| Project | IEEE 802.16 Broadband Wireless Access Working Group < http://ieee802.org/16 > | |
| Title | A frame structure for shared RS in IEEE 802.16j Multi-hop Relay Network | |
| Date Submitted | 2007-4-29 | |
| Abstract | This contribution proposes a frame structure for share RS in IEEE 802.16j MR network. | |

Figure <xxx> Example of configuration for shared RS mode

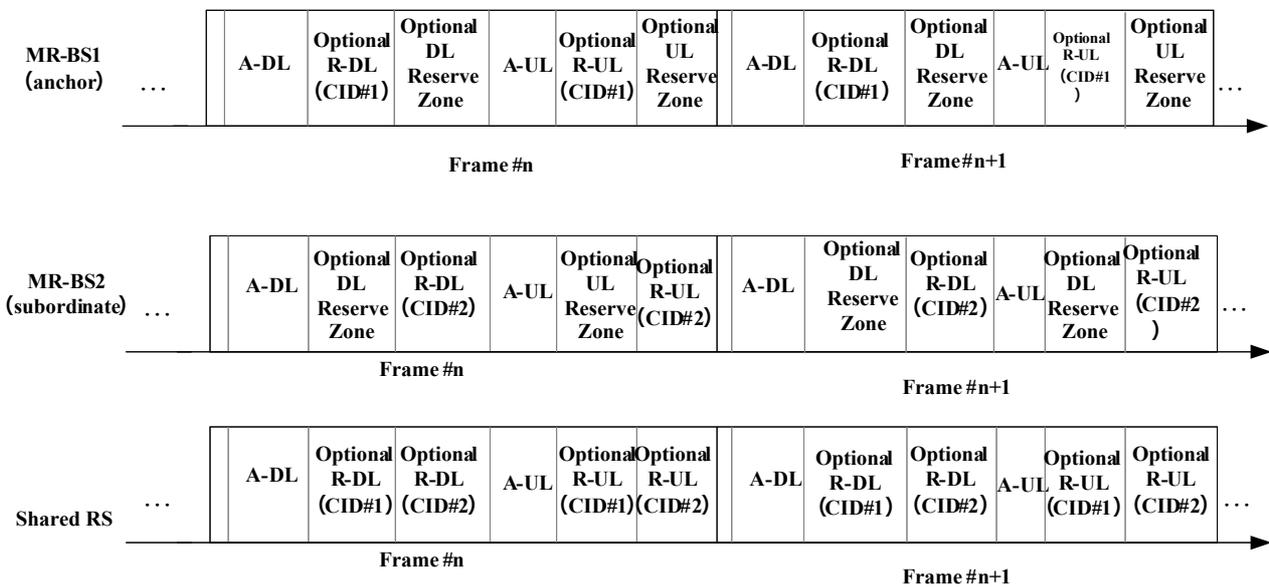
[Insert section 8.4.4.7.3 “Frame structure for shared RS mode” as indicated:]

This section describes the minimal requirements for an in-band frame structure for anchor BS, subordinate BS and the shared RS.

For the TDD mode, an example of the anchor BS frame structure is shown in Figure <xxx>.

The frame structure consists of DL sub-frame period and UL sub-frame period. Each frame in the downlink starts with a preamble followed by FCH, DL MAP and possibly UL MAP. The DL sub-frame shall include at least one DL Access Zone and possibly one DL Relay Zone and possibly one DL Reserved Zone. The UL sub-frame shall include one UL Access Zone and may include one optional UL Relay Zone and one optional UL Reserved Zone. DL/UL Reserved Zone may be used in idle or Access Zone mode. In each frame, the TTG shall be inserted between the DL sub-frame and UL sub-frame. The RTG shall be inserted at the end of each frame.

For the TDD mode, an example of the subordinate BS frame structure is shown in Figure <xxx>.

The frame structure consists of DL sub-frame period and UL sub-frame period. Each frame in the downlink starts with a preamble followed by FCH, DL MAP and possibly UL MAP. The DL sub-frame shall include at least one DL Access Zone and possibly one DL Relay Zone and possibly one DL Reserved Zone. The UL sub-frame shall include one UL Access Zone and may include one optional UL Reserved Zone and one optional UL Relay Zone. DL/UL Reserved Zone may be used in idle or Access Zone mode.

For the TDD mode, an example of the shared RS frame structure is shown in Figure <xxx>.

The frame structure consists of DL sub-frame period and UL sub-frame period. Each frame in the downlink starts with a preamble followed by an FCH, DL MAP and possibly UL MAP. The DL sub-frame shall include at least one DL Access Zone and two optional UL Relay Zones. The UL sub-frame shall include one UL Access Zone and may include two optional UL Relay Zones.

In each frame, the TTG shall be inserted between the DL sub-frame and UL sub-frame. The RTG shall be inserted at the end of each frame. The R-TTG or R-RTG shall be inserted between transmission and reception mode in DL sub-frame and UL sub-frame.
